**Flood Control Project Maintenance
Levee Inspections
LMA District Cover Sheet**

Lower San Joaquin Levee District

Levee Inspection Report By Mile - Spring 2022

Waterway	Bank	Unit Miles	Inspection Start/End	Inspector
Unit No. 01 San Joaquin River	Right	22.52	04/05/2022 04/05/2022	Corey Fujitani

Photo 3 of 3 : UCIP_SP_2022_70664_90727.jpg

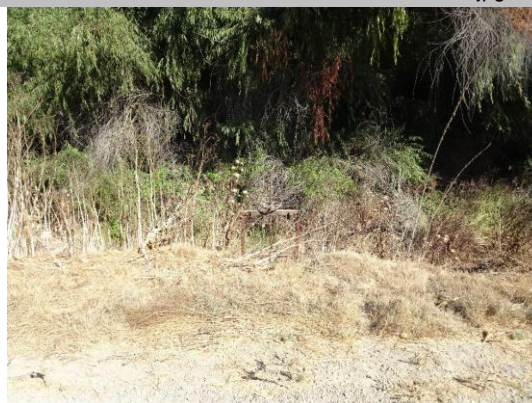
Comment Code						
Inspector Comment						
FS_ID:70664 DS_ID:19615 EP_NO: N/A Repair Type: Urgent Crossing Status: Found UCIP Comments: 10/20/2020 Record has been updated from Non-Urgent to Urgent. Heavy corrosion present with visible holes found at the WS outlet near flap gate. Surface erosion present on the LS slope just upstream of slide gate. Evidence of surface erosion on the WS slope (vertical slope) was present approximately 15 feet downstream of the pipe. Plastic sheeting has been placed to prevent further erosion by LMA (assumed). Recommend notifying DWR Levee Inspector to monitor progress of surface erosion on the WS. No permit was found authorizing this encroachment. CVFPB will need to review crossing to determine owner. DWR DMP internal inspection is pending and scheduled for 2021. (B. Singh - GEI, O. Magana - DWR UCIP)07/19/2016 Potential LS slope damage--difficult to determine due to dense vegetation. Limited access on WS toe due to wire fence. (O. Magana - DWR UCIP)04/08/2014 Slide gate blocked by debris at LS toe. Flapgate won't close because of debris. Dense vegetation limits the inspector's visibility to identify signs of pipe failure (leaks) along the slope. Recommend removing vegetation along pipe alignment to conduct proper inspection of structure and appurtenances. (W. Wylie - DWR UCIP) FIELD_STRUCT_DESC: 36-inch corrugated metal (CM) gravity drainage pipe through the levee, 10.3 feet below the crown. Slide gate on the landside (LS) toe. Flap gate on the waterside (WS) end. Brass cap No. 90 bench mark (BM) on the headwall on the LS. [Additional Reference(s): DWR Levee Log, 2002, (HLM 6.90). USACE San Joaquin O&M Manual, Unit No. 601, Part No. 1, (SJR601.1), 1967, Revised 25 May 2011, (HLM 6.90)]. FS Date: 10/20/2020

LS view: Pipe slidegate visible at LS toe.

Photo 1 of 1 : SP_2022_NA0010_118_142_20220412_00311.jpg

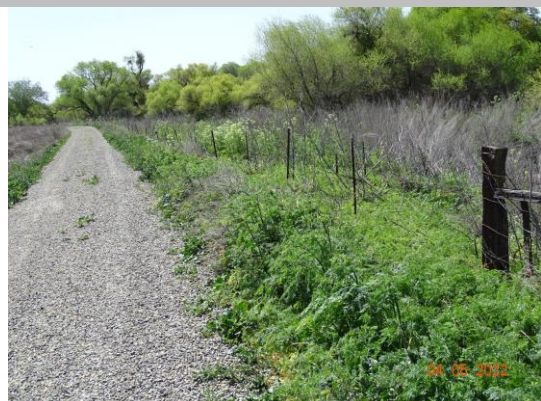
LM Start	20.26	Rating **	M	Issue No.	142
LM End	22.50	Issue Type +	Ma	Location *	WS
Category	Earthen Levee			GPS Latitude/Longitude	
				Start	End
Item	Vegetation			37.193632 °	37.167104 °
				-120.760194 °	-120.750272 °
DWR ID	DWR_NA0010_01_s_2022_142				
Comment Code					
V1 : Control annual grass and weeds on the levee slopes and easements.					
Inspector Comment

View of vegetation growing on the waterside slope. (Spring 2022)

Photo 1 of 1 : SP_2022_NA0010_123_102_20220414_00366.jpg

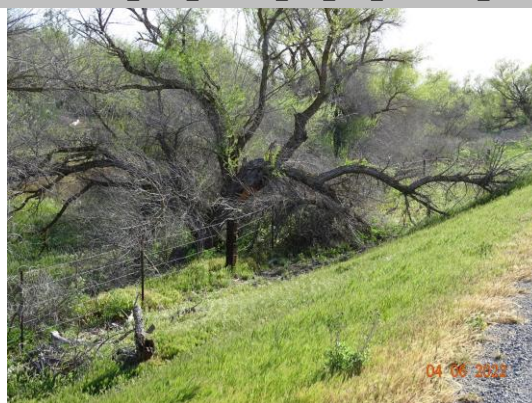
LM Start	2.82	Rating **	M	Issue No.	102
LM End	2.82	Issue Type +	Ma	Location *	LS
Category	Earthen Levee			GPS Latitude/Longitude	
				Start	End
Item	Encroachments			37.256805 °	37.256805 °
				-120.785434 °	-120.785434 °
DWR ID	DWR_NA0010_05_s_2019_102				
Comment Code					
TR : Tree or limb					
Inspector Comment

Tree limb has fallen on the landside slope and toe. (Spring 2022)

Photo 1 of 3 : UCIP_SP_2022_71034_104120.jpg

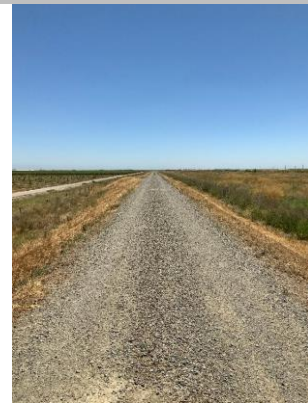
Comment Code						
Inspector Comment						
FS_ID:71034 DS_ID:19746 EP_NO: N/A Repair Type: Non-Urgent Crossing Status: Found UCIP Comments: 06/22/2021 The record remains Non-Urgent. Crossing appears to be in good condition. No permit was found authorizing this encroachment. CVFPB will need to review crossing to determine owner. The UCIP inspection was completed with GEI staff, P. Espinoza. (H. Dunn ? GEI) 04/23/2014 Dense vegetation limits the inspector's visibility to identify signs of pipe failure (leaks) along the landward slope. Recommend removing vegetation along pipe alignment to conduct proper inspection of structure. (W. Wylie - DWR UCIP) FIELD_STRUCT_DESC: 24-inch corrugated metal gravity drainage pipe (CMP) through the levee, 10.0 feet below the crown. Flap gate on the waterside (WS) end. Concrete headwall on the landside (LS) end. Concrete U-shaped headwall on the WS end. [Additional Reference(s): DWR Levee Log, 2002, (HLM 18.68). USACE San Joaquin O&M Manual, Unit No. 601, Part No. 1, 1967, Amended in 1978, Revised 20 June 1985, (HLM 18.68). DWR As-Built Specification No. 64-01, Sheet No. 3, 6 November 1963, (HLM 18.68)]. FS Date: 6/22/2021

Photo 1 of 3 : UCIP_SP_2022_71039_104146.jpg

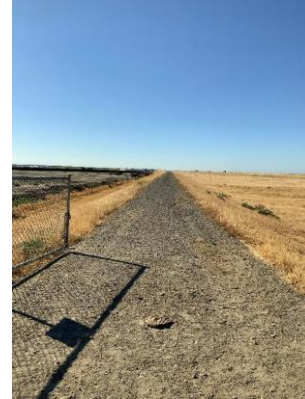
Comment Code						
Inspector Comment						
FS_ID:71039 DS_ID:19778 EP_NO: N/A Repair Type: Non-Urgent Crossing Status: Found UCIP Comments: 06/23/2021 The record remains Non-Urgent. DWR DMP internal inspection has not found pipe integrity issues. LOF of crossing is less or equal to 4.0. Recommend next video inspection in 5 years. No permit was found authorizing this encroachment. CVFPB will need to review crossing to determine owner. The UCIP inspection was completed with GEI staff, P. Espinoza. (H. Dunn ? GEI) 04/23/2014 Dense vegetation limits the inspector's visibility to identify signs of pipe failure (leaks) along the landward slope. Recommend removing vegetation along pipe alignment to conduct proper inspection of structure. Sediment buildup in pipe visible from landward side-- recommend contacting owner to clear pipe. (W. Wylie - DWR UCIP) FIELD_STRUCT_DESC: 24-inch corrugated metal gravity drainage pipe (CMP) through the levee, 9.7 feet below the crown. Flap gate on the waterside (WS) end. Concrete headwall on the landside (LS) end. Concrete U-shaped headwall on the WS end. [Additional Reference(s): DWR Levee Log, 2002, (HLM 19.50). USACE San Joaquin O&M Manual, Unit No. 601, Part No. 1, 1967, Amended in 1978, Revised 20 June 1985, (HLM 19.50). DWR As-Built Specification No. 64-01, Sheet No. 3, 6 November 1963, (HLM 19.50)]. FS Date: 6/23/2021

Photo 3 of 3 : UCIP_SP_2022_71110_103078.jpg

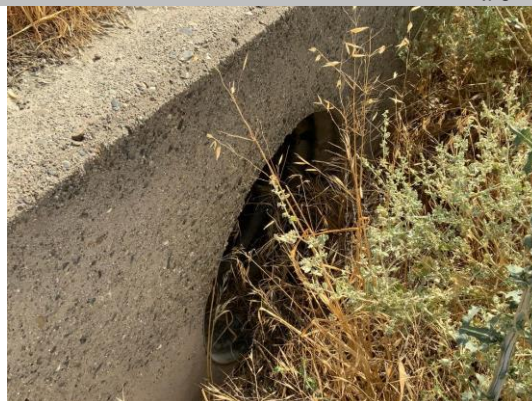
LS view: Closeup of pipe inlet at toe with vegetation growth.

Photo 3 of 3 : UCIP_SP_2022_71147_103942.jpg

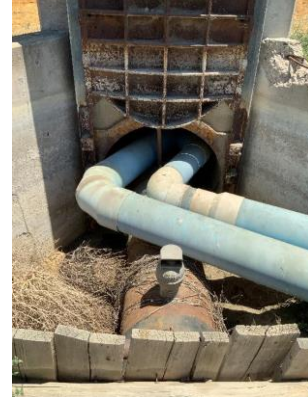
LS view: Closeup of slide gate and unauthorized 12" pipes going through outlet pipe at toe, 1 of 2 photos.

Photo 1 of 3 : UCIP_SP_2022_67621_100425.jpg

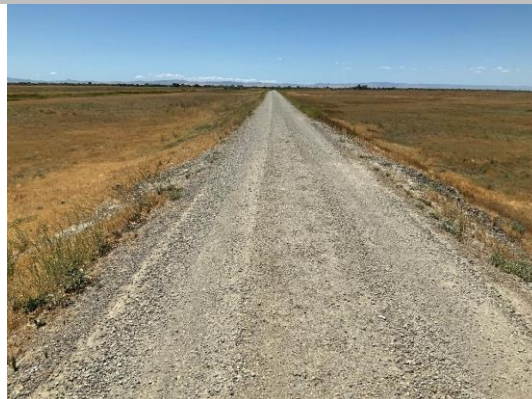
Comment Code						
Inspector Comment						
FS_ID:67621 DS_ID:19848 EP_NO: N/A Repair Type: Non-Urgent Crossing Status: Found UCIP Comments: 06/8/2021 The record remains Non-Urgent. DWR DMP internal inspection has not found pipe integrity issues. LOF of crossing is less or equal to 4.0. Recommend next video inspection in 5 years. No permit was found authorizing this encroachment. CVFPB will need to review crossing to determine owner. The UCIP inspection was completed with GEI staff, P. Espinoza. (H. Dunn - GEI) 04/18/201 Need to contact owner. Recommend clearing sediment deposit inside pipe. (O. Magana - DWR UCIP) FIELD_STRUCT_DESC: 24-inch corrugated metal gravity drainage pipe through the levee, 10.3 feet below the crown. Flap gate on the waterside (WS) end. [Additional Reference(s): DWR Levee Log, 2002 (HLM 0.85), listed as a 24-inch corrugated metal pipe (CMP). USACE San Joaquin O&M Manual, Unit 601 Part 1 (SJR601.1), 1967, (HLM 0.84), listed as a 24-inch CMP]. FS Date: 6/8/2021

Photo 3 of 3 : UCIP_SP_2022_68909_102608.jpg

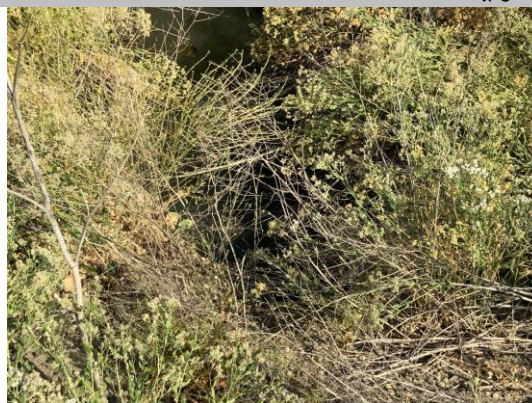
LS view: Pipe outlet covered by dense vegetation at toe.
